# Airworthiness Directive Schedule

### Airbus Helicopters AS 350 Series

22 December 2022

**Figure: Airbus Helicopters recommended CG position of forward two-place seat**

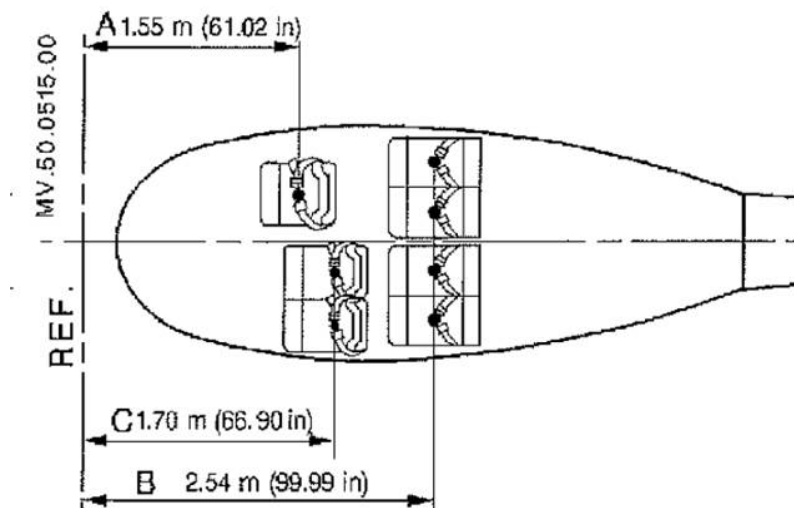
**Requirement:** To prevent a reduction of flight safety from that provided by the manufacturer, accomplish the following:

1. Determine the longitudinal moment arm of the forward two-place seat using the center of the seat pan cushion as a measurement reference point.  
Complete and issue a new form CAA 2173 Weight and Balance Data.  
The weight of the seat components must be included in the CG calculations. If a seat adaptor plate is fitted the moment (position and weight) of the plate must also be considered for the CG calculation.  
The lateral CG arm of the helicopter must not be assumed to be zero. The lateral CG must be recorded and be within the limits specified in the AFM.  
Annotate the CAA2173 to include the value of the longitudinal moment arm of the forward two-place seat used.
2. Remove CAA Limitations Section, (1 page), dated 14 December 2015 and insert 1 page dated 30 June 2016.
